**DEVIATION REQUEST  
AND DECISION FORM**

Project Name : Hillside at Lorson Ranch  
 Schedule No.(s) : 5500000370, 5500000371, 5500000405, 5500000281, 5500000282, & 5500000283  
 Legal Description : See Attached

**DEVIATION 2  
EXHIBIT**

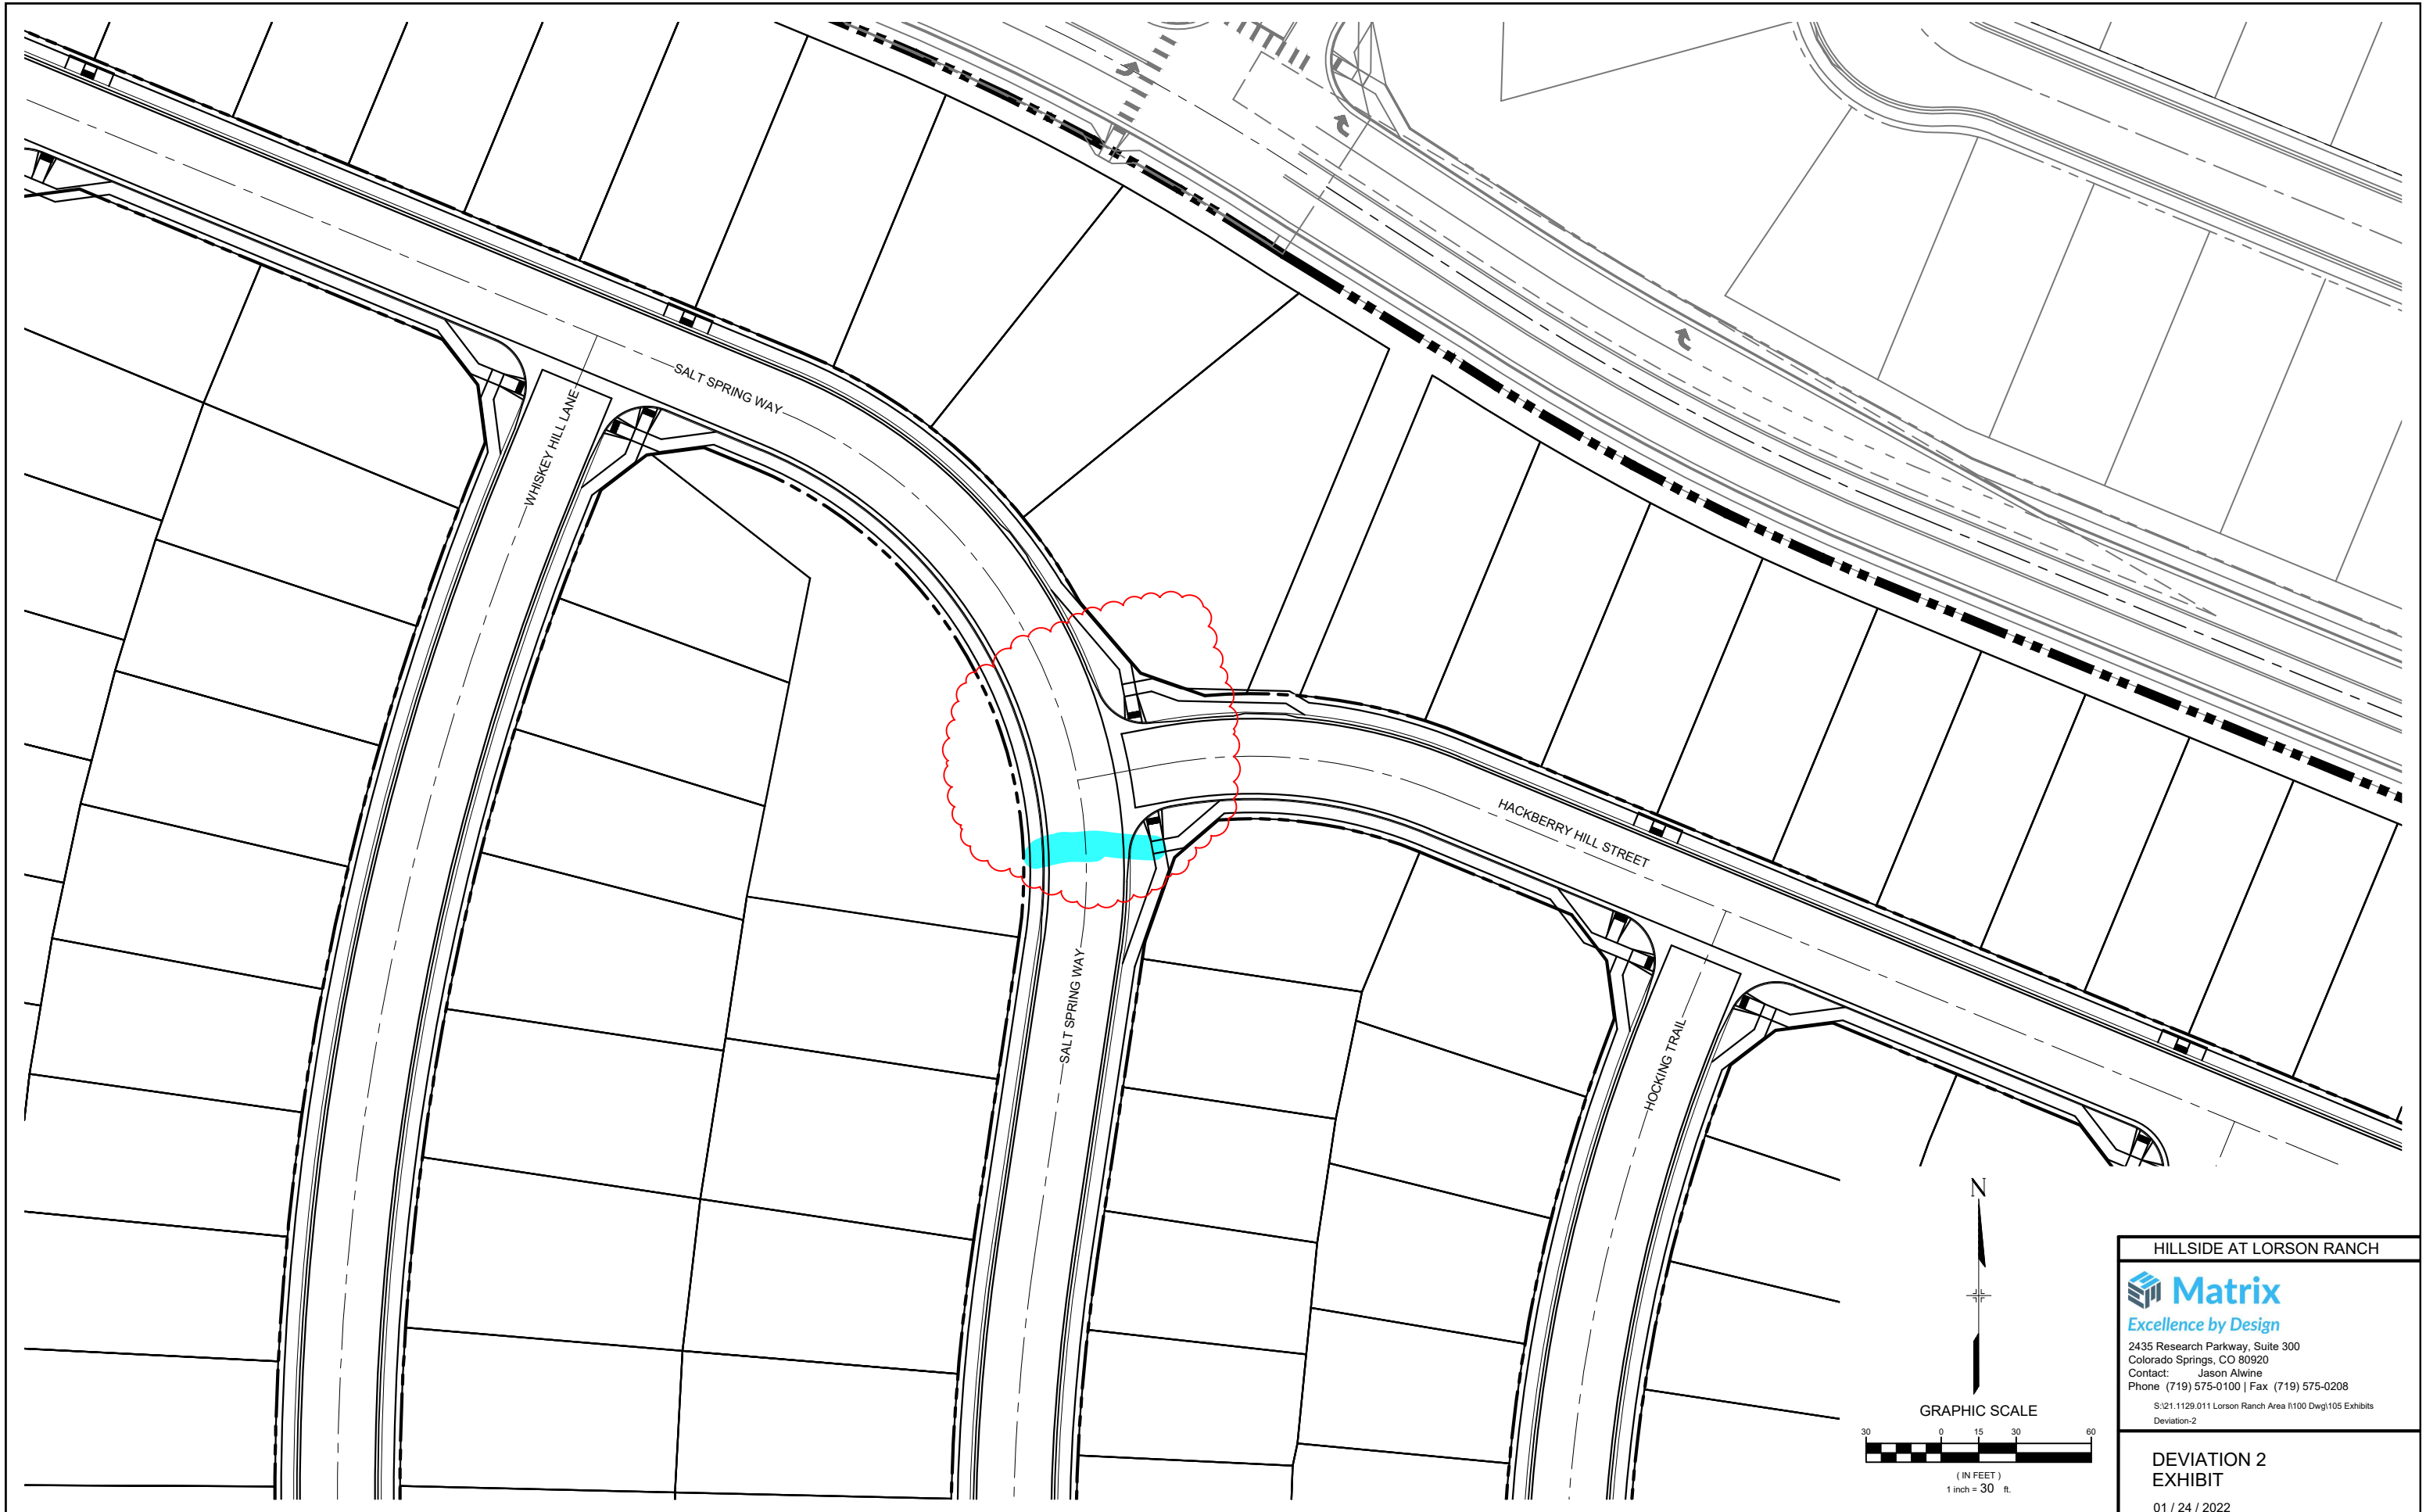
Allow only two pedestrian ramps to be constructed at the T-intersection of Hackberry Hill Street and Salt Spring Way.

The proposed alternative is to construct two pedestrian ramps crossing Hackberry Hill Street and no ramps crossing Salt Spring Way at this T-intersection. The ECM standard is for T-intersections to have a minimum of four curb ramps.

The intersection is in close proximity of other intersections with all the required ramps constructed. Installation of an additional two ramps at this intersection is not feasible as the grading cannot meet ADA requirements along the ADA curb returns. The additional ramps may also be a safety concern as the removed crossing is in the middle of a large curve. The crossing at Salt Spring Way and Whiskey Hill Lane is approximately 225' feet away and provides a much safer intersection for pedestrian movements.

Elimination of two of the four ramps at this intersection will not impede pedestrian movements and will result in safer pedestrian crossing due to grading concerns and the inability to meet ADA slope requirements (where required). The additional ramps may also be a safety concern as the removed crossing is in the middle of a large curve. A pedestrian will be able to cross at alternate locations within approximately 225' of the eliminated ramps.

3 for a T  
intersection
